5. Consideration Of Draft Change Order No. 4 To COF Contract No. 2017-0264 With Kiewit Infrastructure South Co, For The Water Reclamation Facility Modifications & Expansion Project.

Consideration Of Draft Change Order No. 4 To COF Contract No. 2017-0264 With Kiewit Infrastructure South Co, For The Water Reclamation Facility Modifications & Expansion Project.

The purpose of this memorandum is to provide information to the Franklin Board of Mayor and Aldermen (BOMA) concerning Change Order No. 4 for the Water Reclamation Facility Modifications & Expansion Project.

PROJECT: City of Franklin, Tennessee
Franklin WRF Modifications & Expansion Project

SITE LAYOUT AND YARD PIPING PLAN
PANEL 4

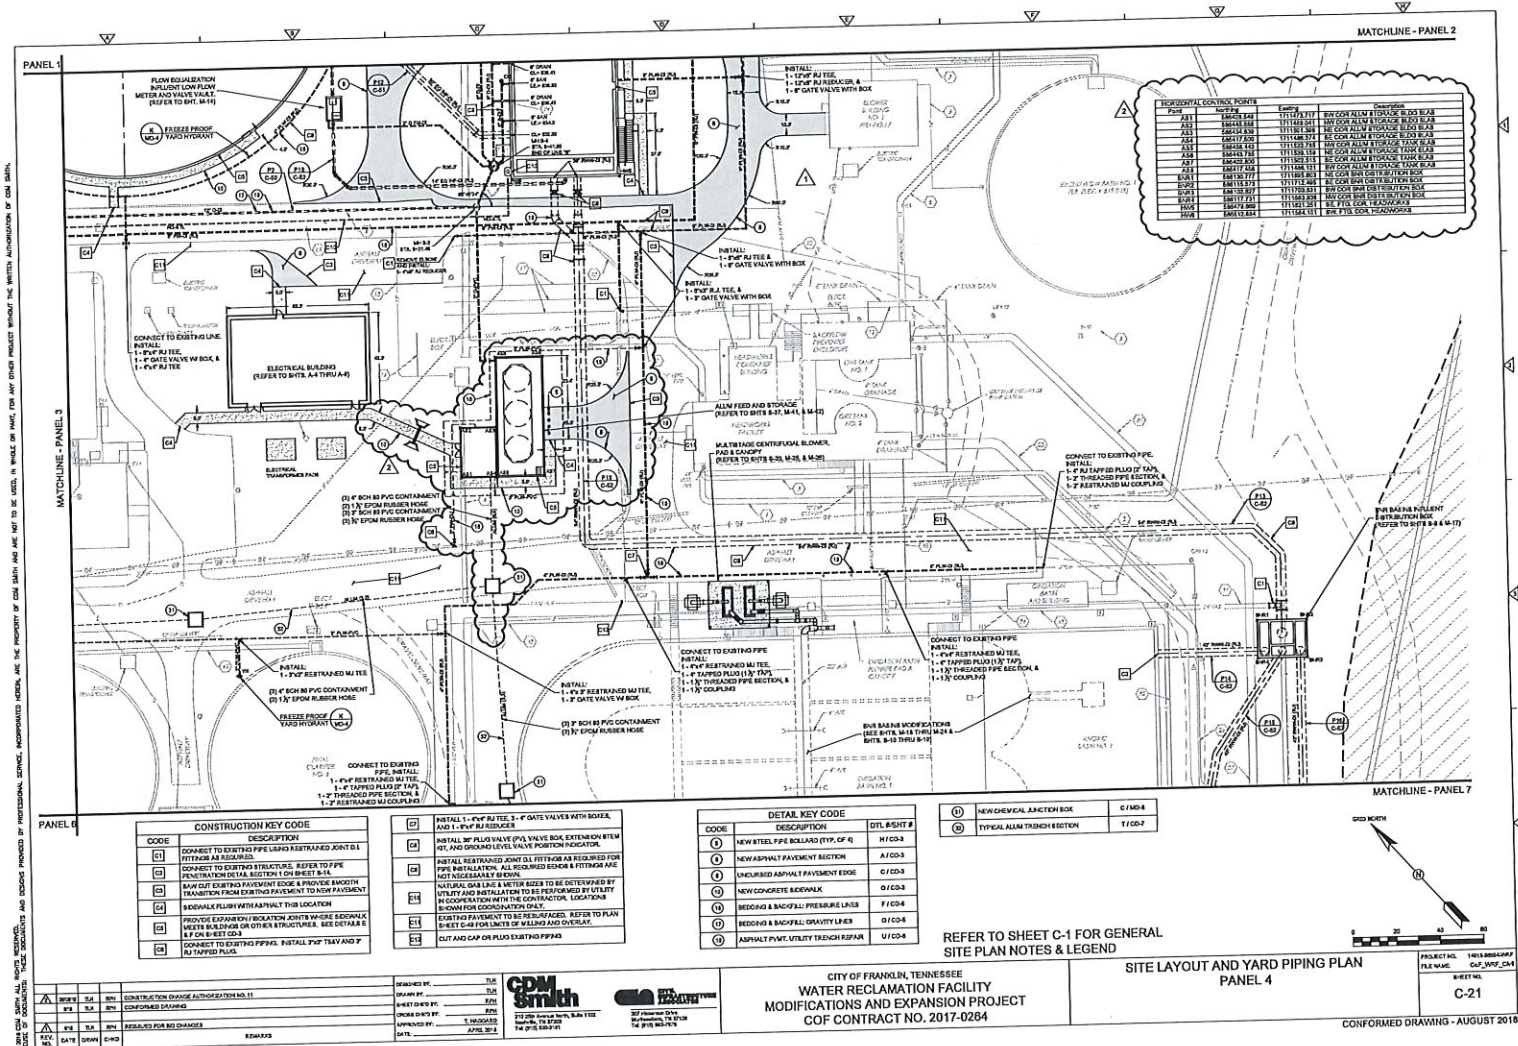
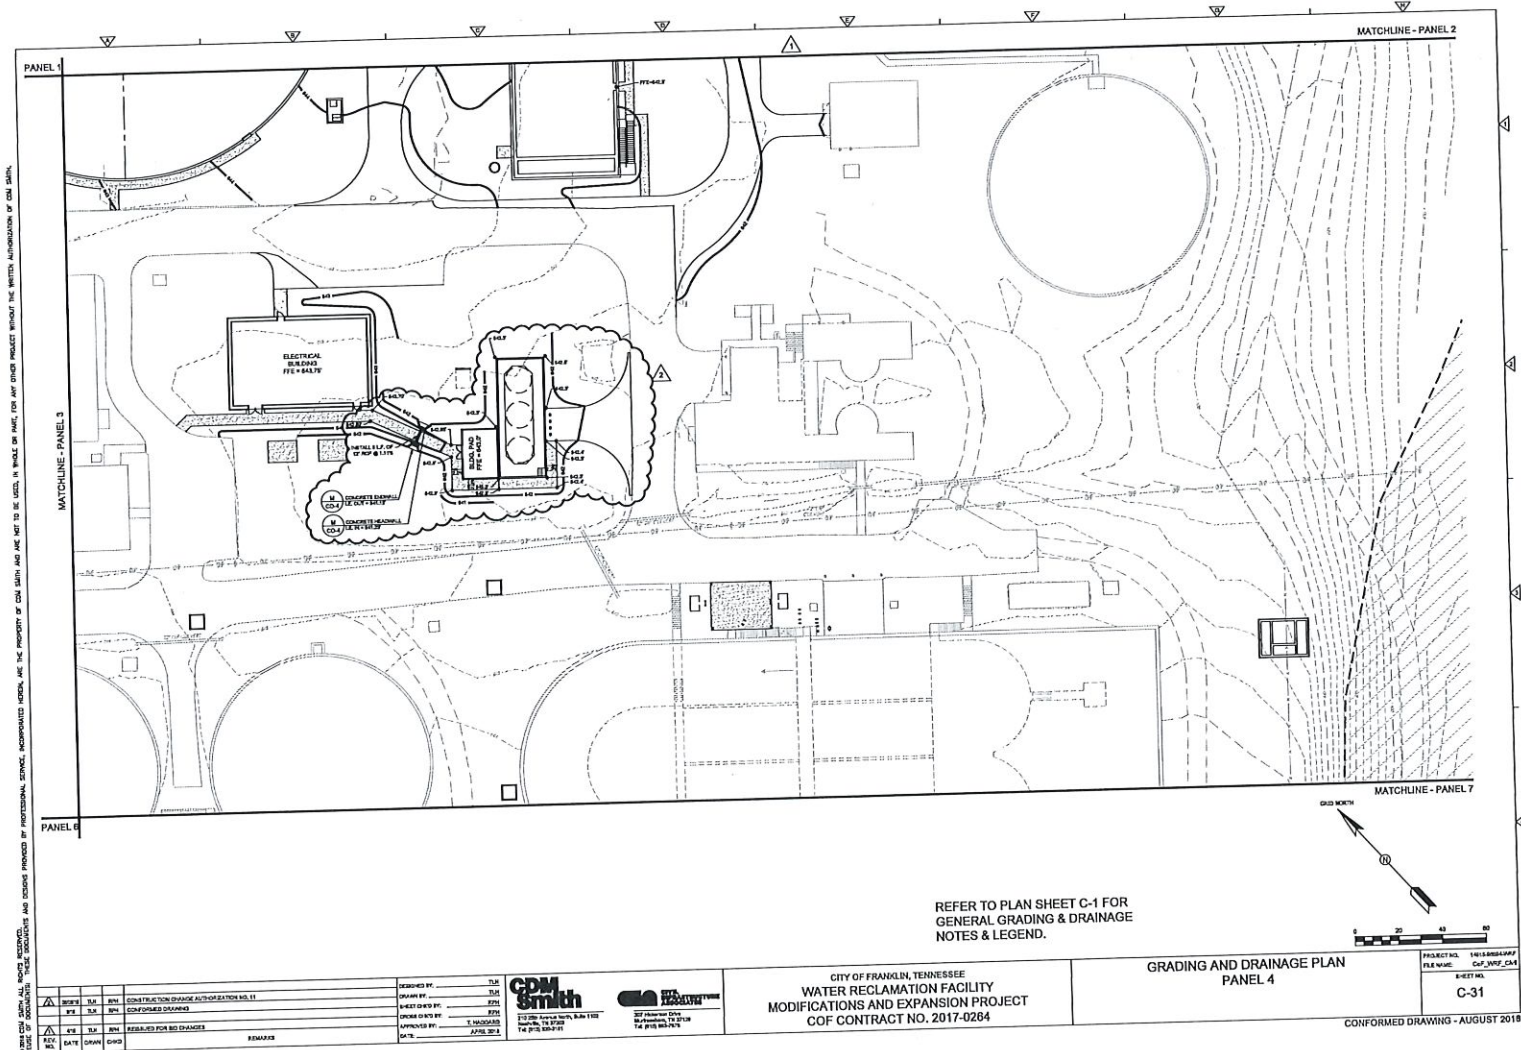
DESCRIPTION: The Alum Storage & Feed Facility design requires revision due to a conflict with an existing pipeline as shown on the attached drawings and summarized below by affected drawing;

- Relocate easternmost building line app. 15' to the west and shift new asphalt drive.
- Rotate/realign the feed pump room as shown with double doors facing west.
- Reroute 3" PLW-PVC and tie-ins to match new feed pump room location.
- Add new 5' concrete walkway as shown.
- Relocate tie-in point for new 2" PW-CU and shift location of new Chemical Junction Box.
- Remove existing abandoned 24" line to min. 12" beyond the limits of structural fill material (not indicated on this drawing). Plug or cap open ends per Note 11-B, Sh. C-1.

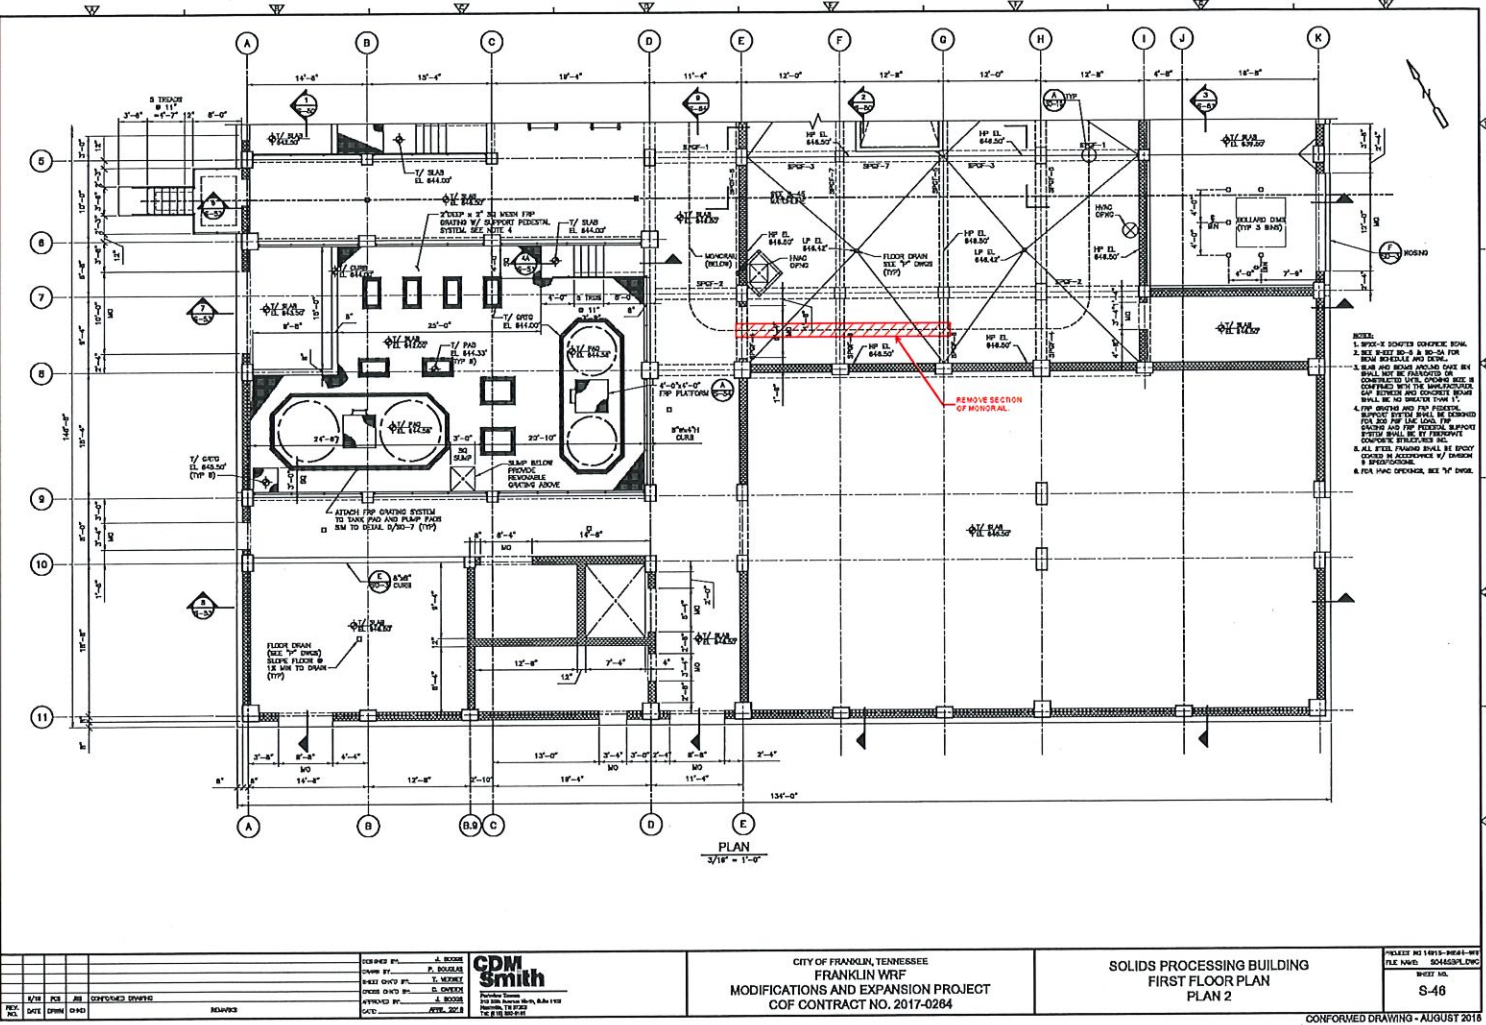
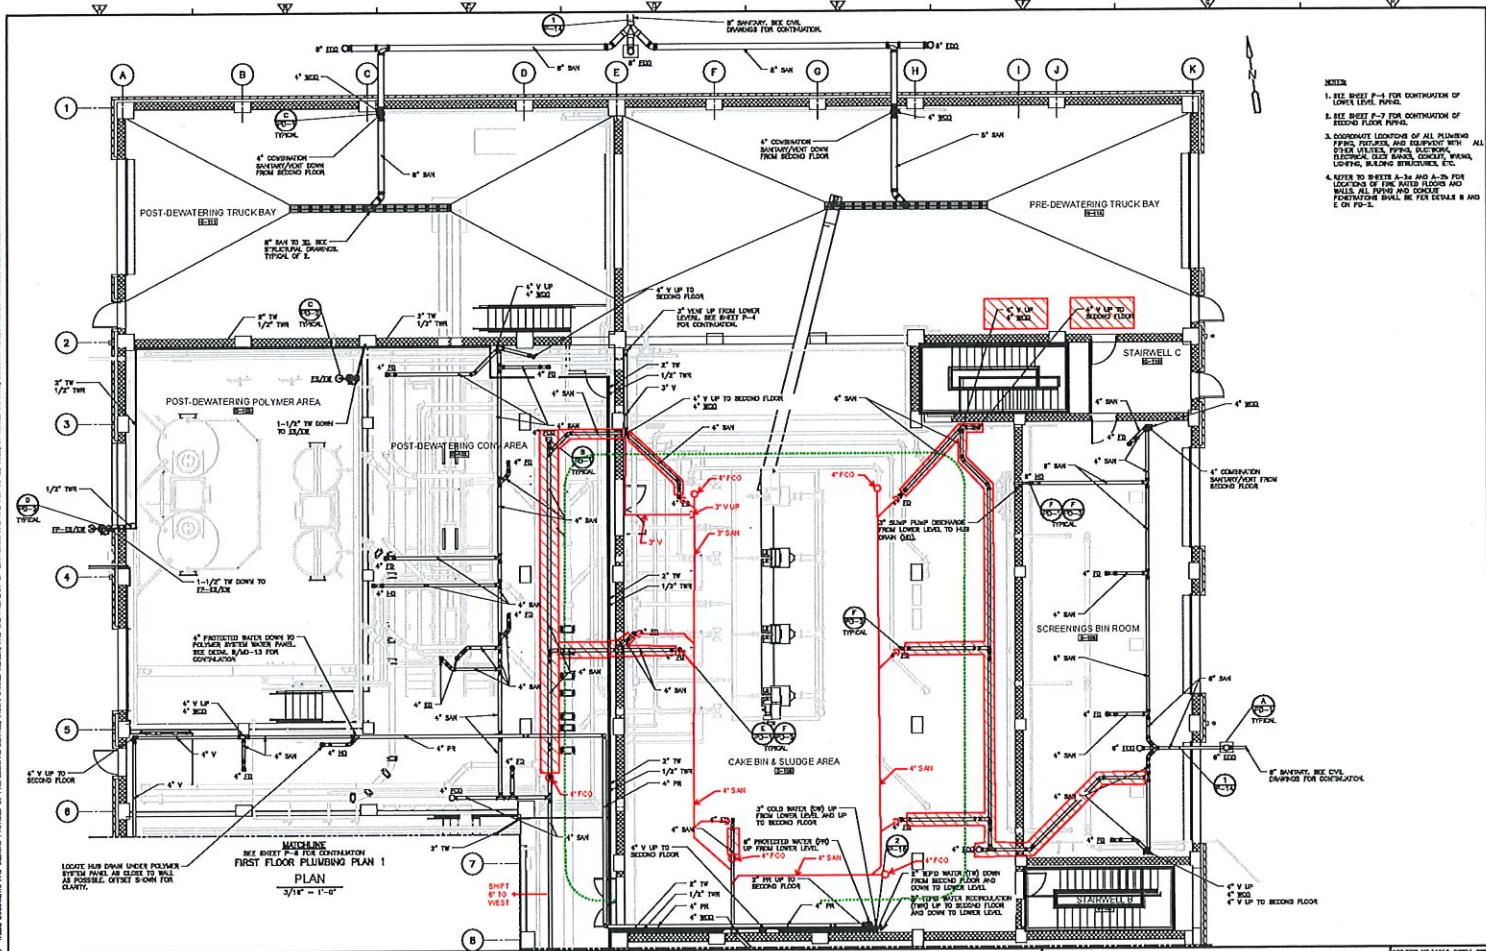
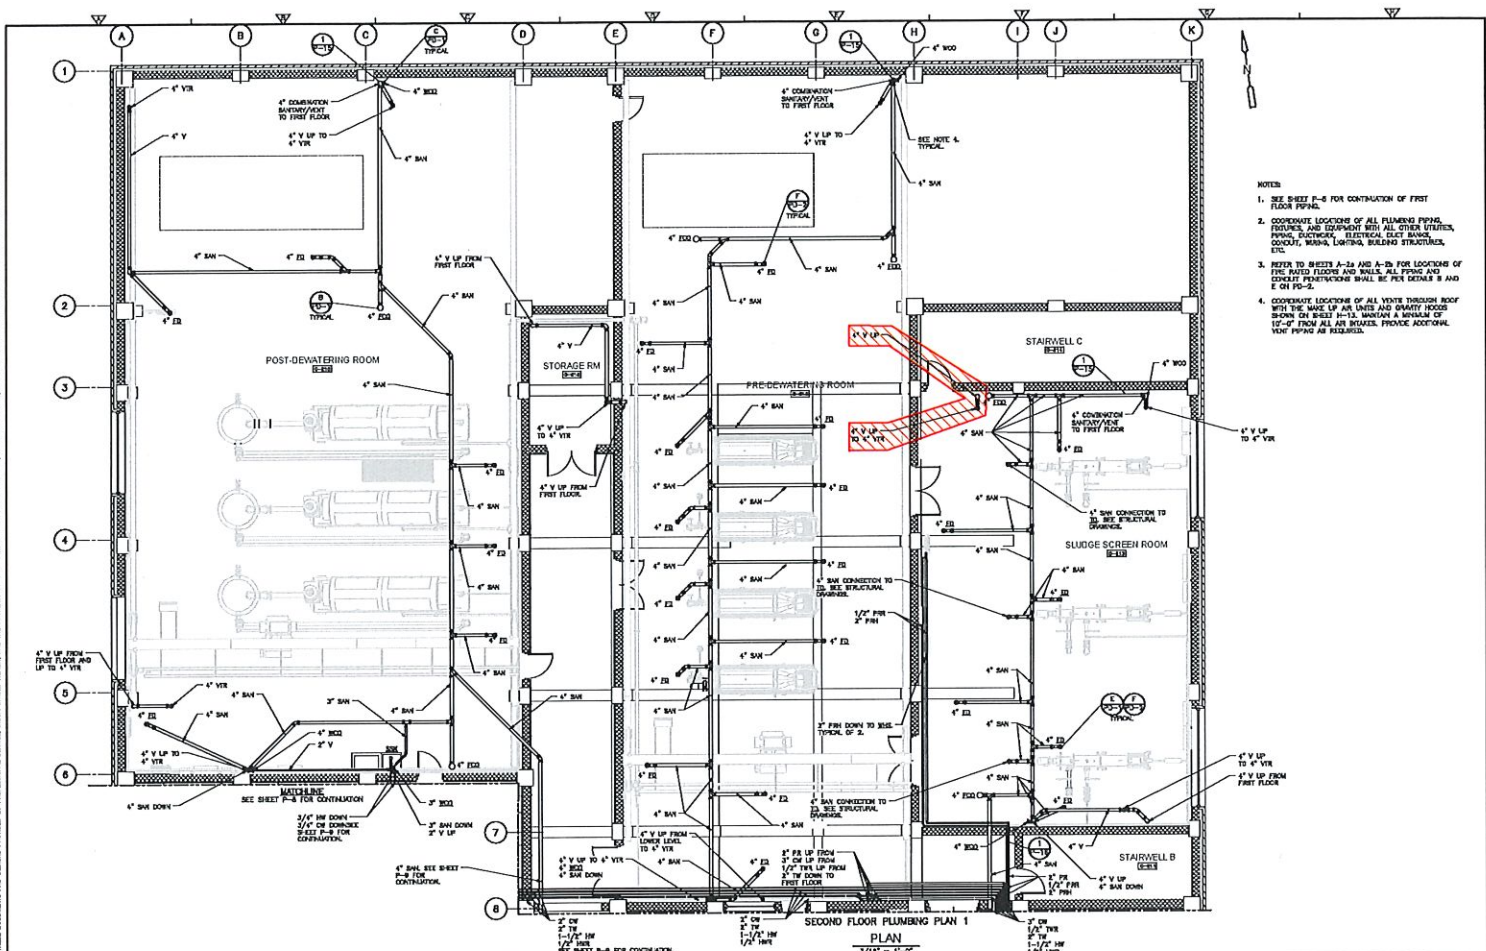
1. In order to resolve piping and ductwork conflicts on the south side of the lower level, south of Column Line 7, it is necessary to delete the section of track between Column Lines E and G. Provide an end stop at each end of the track. Refer to the attached mark-ups on Sheet S-46.

2. In order to resolve conflicts between the monorail/structural beams and the plumbing sanitary/vent piping located at the ceiling of the lower level Cake and Sludge Bin Area, modify the pipe routing as shown on the attached mark-ups on Sheets P-5 and P-7.
 - a. Sanitary piping serving the floor drains and equipment drains in the first floor Cake and Sludge Bin Area will be routed to the 4" sanitary connection to the 6" sanitary main located near the intersection of column lines F and 8.
 - b. Vent piping for the revised layout will be routed to the west from the western sanitary line running north-south near column line F, and then north along column line E to the 4" vent riser at the intersection of

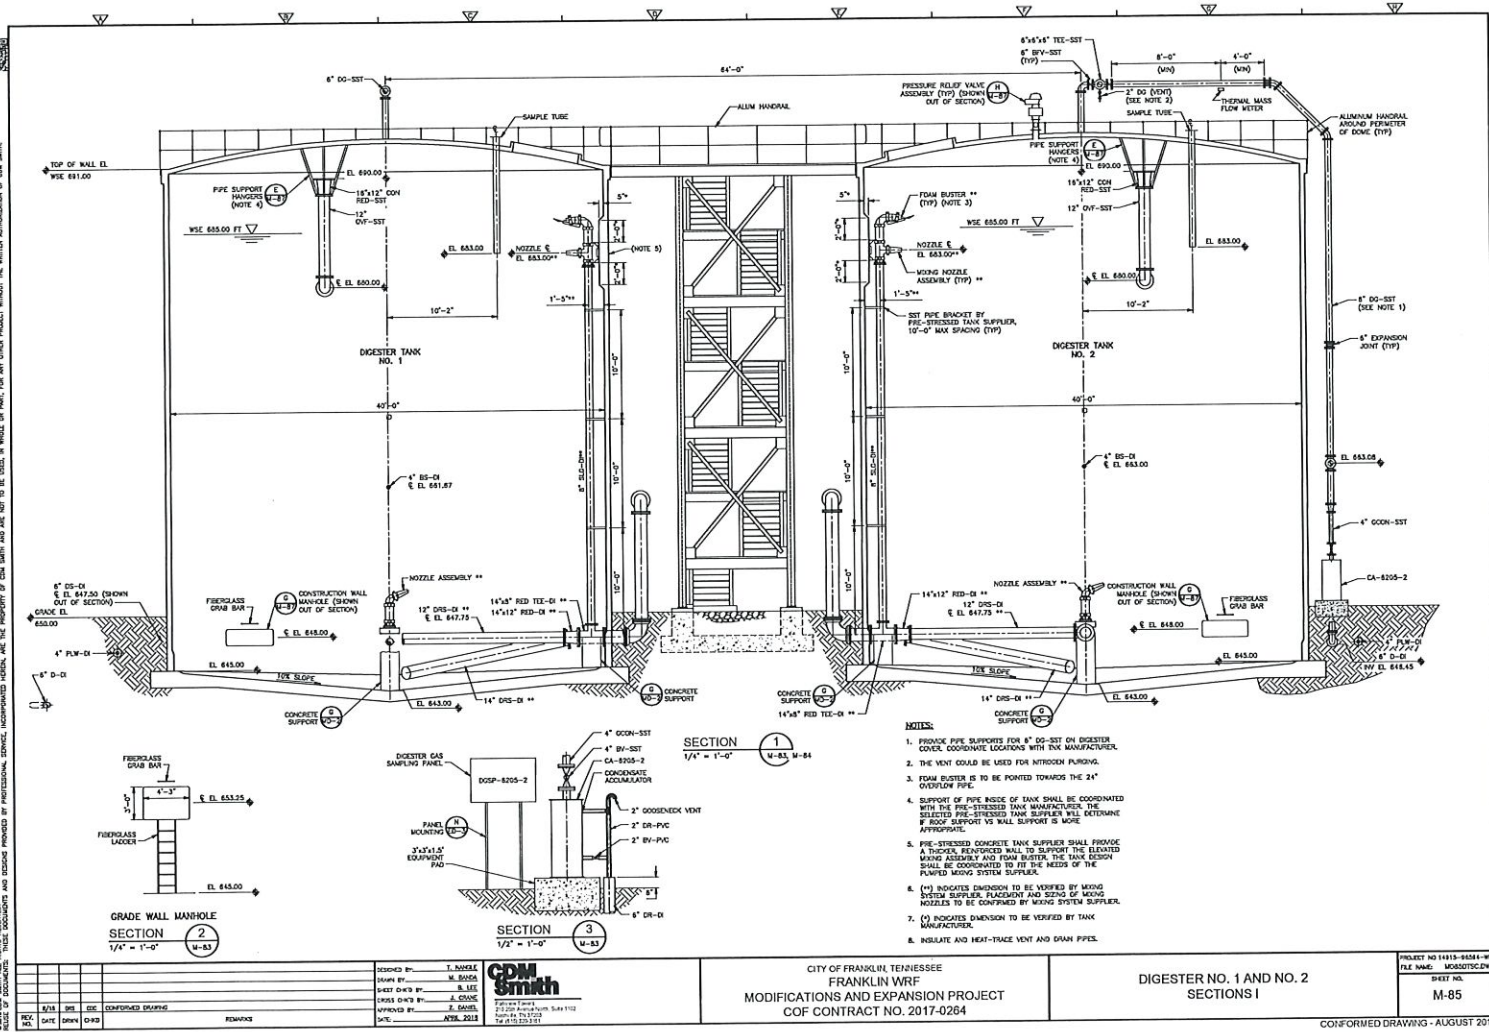
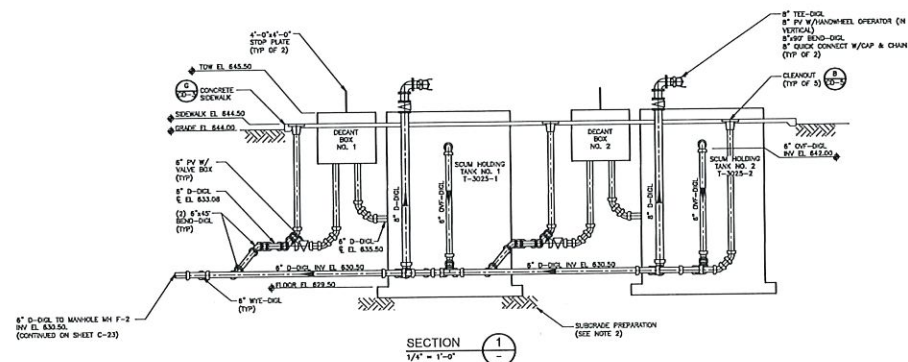
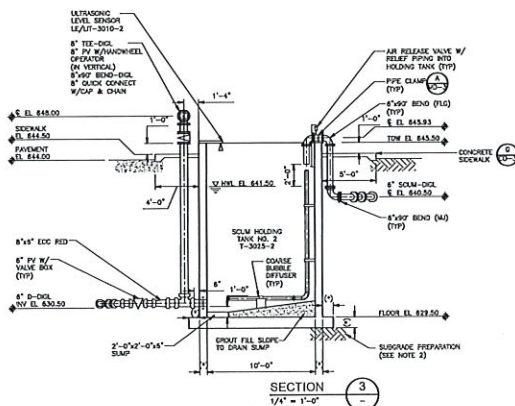
1) Drawing M-85 shows the Anaerobic Digester Tanks section view but does not show #57 Stone with a layer of 8 oz. non-woven geotextile fabric. Section views for other wire wrapped pre-stressed concrete tanks called out either 12" or 24" of #57 Stone with 8 oz. non-woven geotextile fabric. Please confirm if #57 stone with 8 oz. non-woven geotextile fabric is required.

2) Drawings M-97 and M-98 show section views of the Scum Holding Tanks and Decant Boxes but does not show #57 Stone wrapped in 8 oz. non-woven geotextile fabric. Section views for all other precast structures call out #57 Stone wrapped in 8 oz. non-woven geotextile fabric. Please confirm if #57 stone wrapped in 8 oz. non-woven geotextile fabric is required.

PROJECT NO 14815-85584-WP
FILE NAME: E0655DPL.DWG
SHEET NO.
E-88

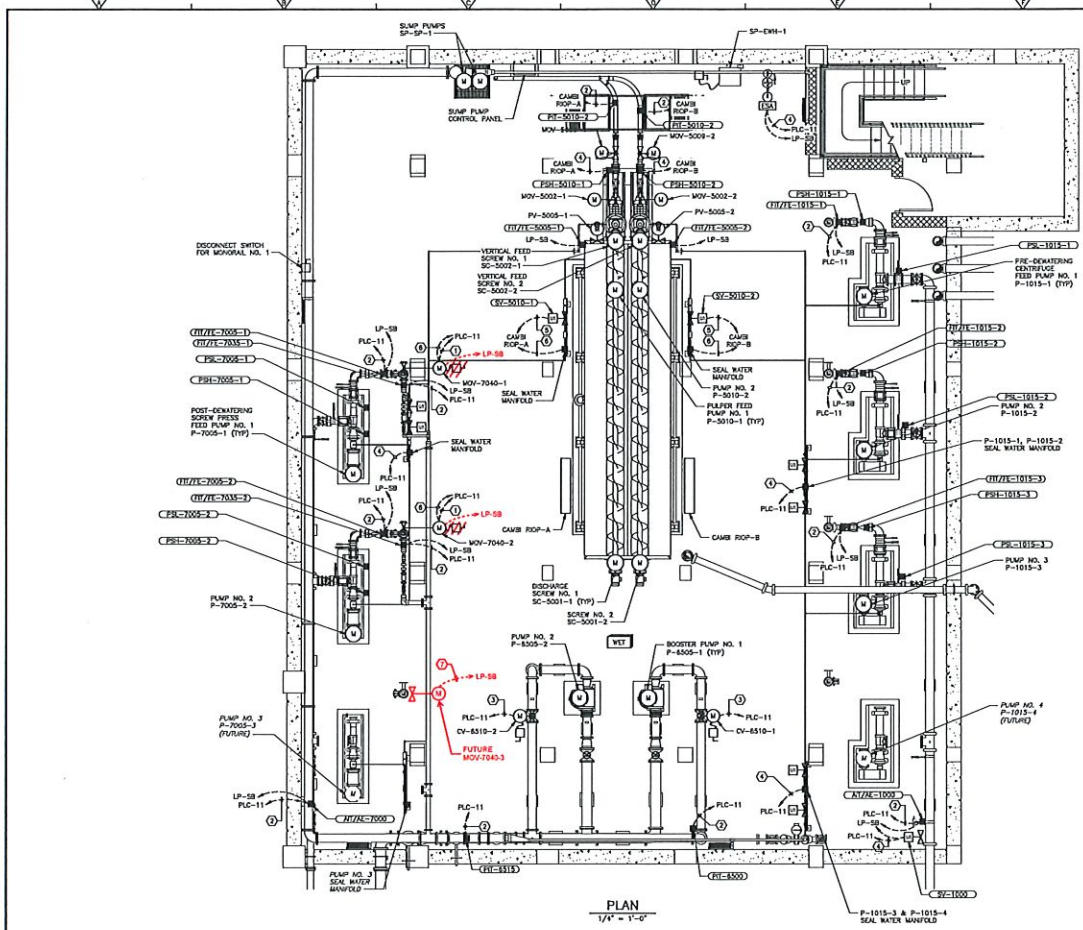
MOV-7040-1 and MOV-7040-2 are shown on drawing E-88 (see attached) however they are not shown on the single line diagrams. Please provide a location and circuit size for this equipment.
